PLANNING DEPARTMENT – Development Review Services

**RE: RGNC State Park Parking Lot
Grading & Drainage Plan
Engineer's Stamp Date 11-18-2015 (File: F12D001)**

SITE GRADING &
DRAINAGE PLAN

1 GRADING & DRAINAGE PLAN

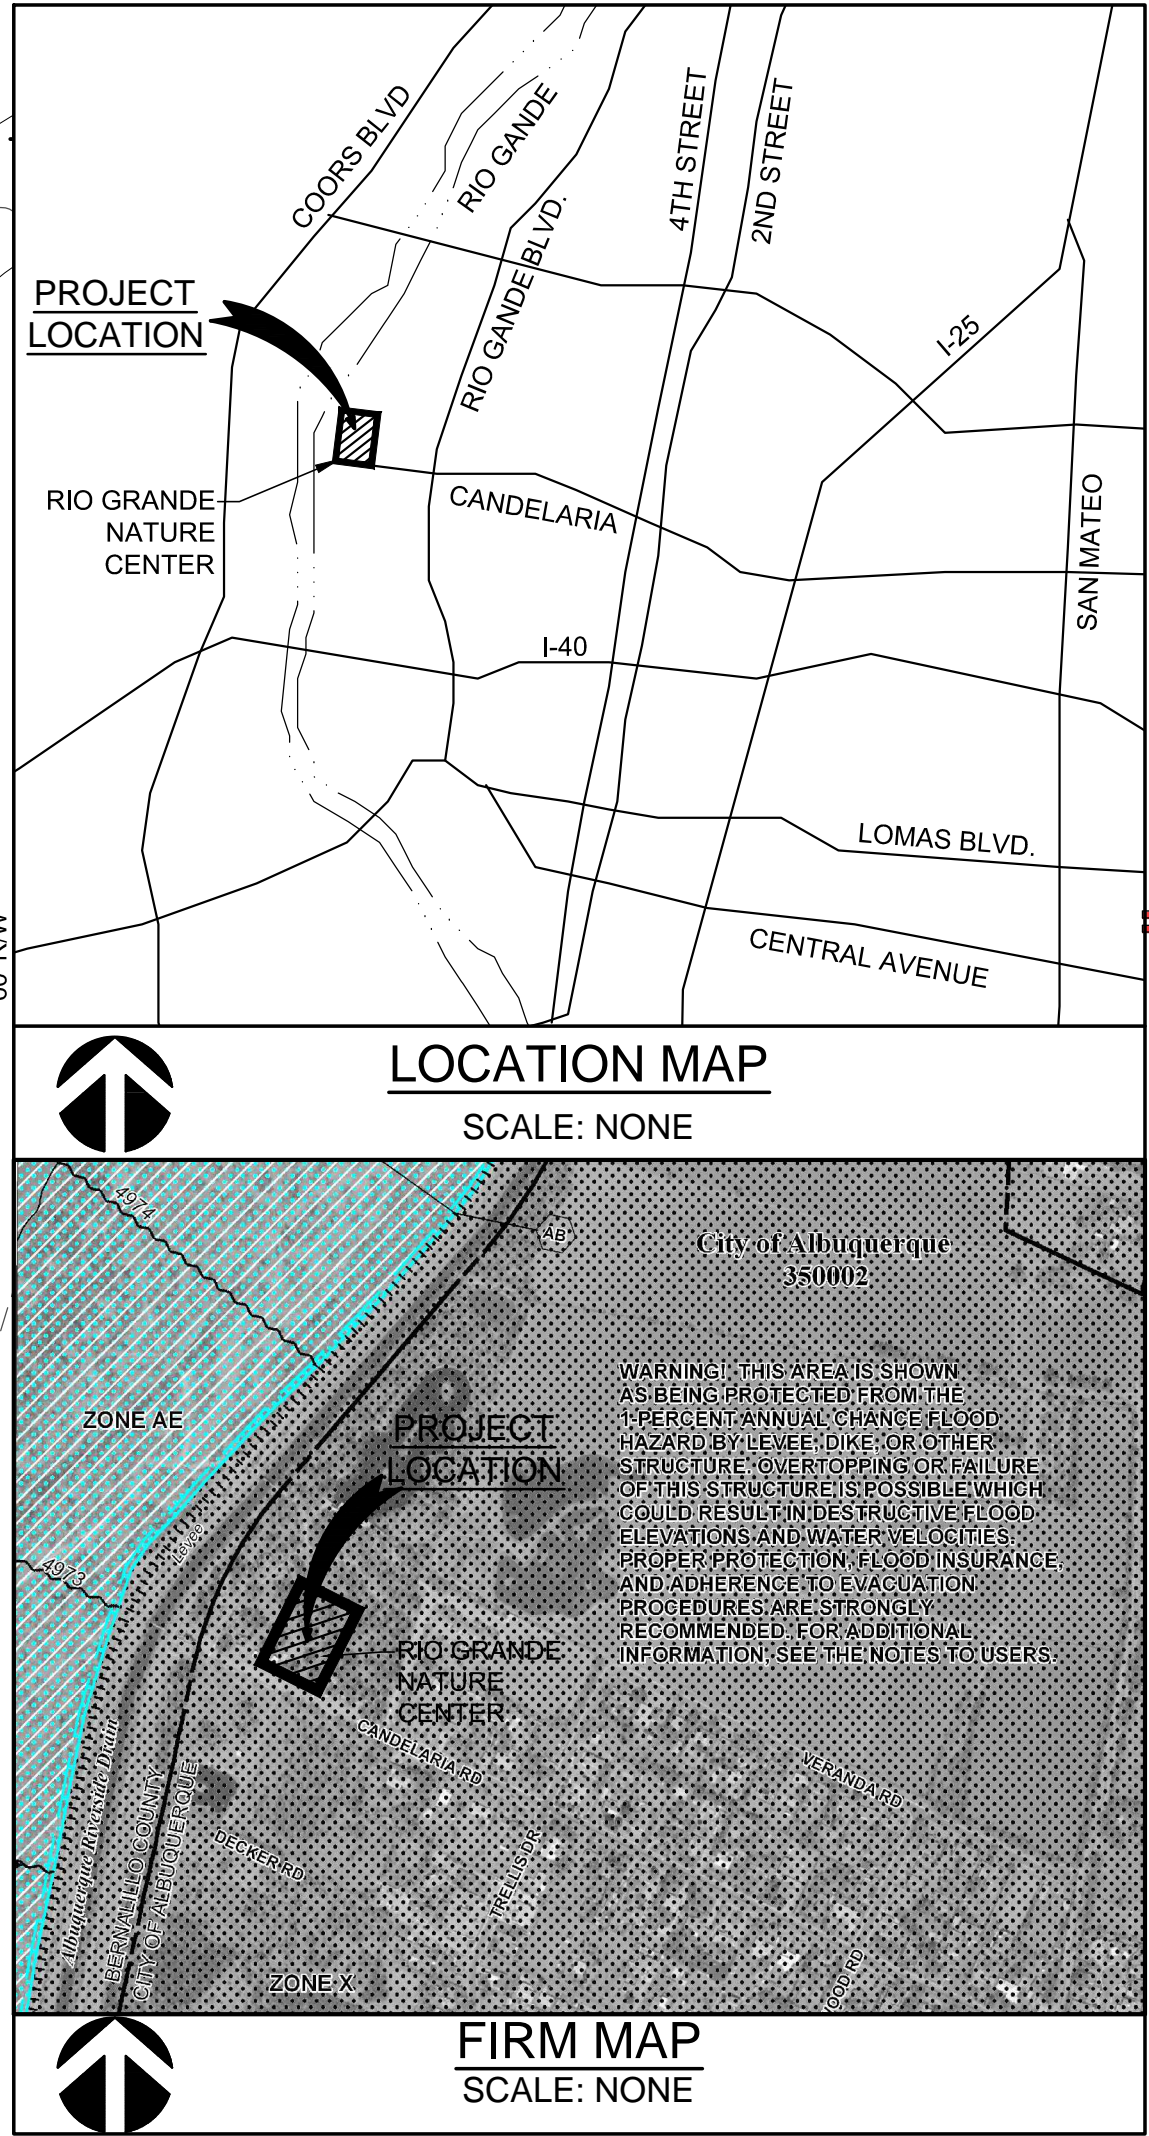
1. The existing parking site is 1.81 with the proposed expansion being 2 acres, for a total of 3.81 Acres. The existing site is gravel and flat, so it appears runoff either infiltrated, or flowed to a low area on the proposed expansion. This historic drainage pattern must be maintained. The submitted plan shows that the low area is not being reduced in volume. If fact a shallow pond shows that additional volume (5194CF-2178CF = 3016 CF) is being provided which is an improvement of current conditions.

2. However, there is not in our records a grading plan for the existing lot, and volume for the 100-yr storm should have been retained within the property boundaries. In order to protect the lots to the south, provide a berm along the south property line that would contain the volume for the entire site based on the 100-yr storm. Show the berm on the as-built plan with the Engineer Certification which is to be submitted at the completion of the project.
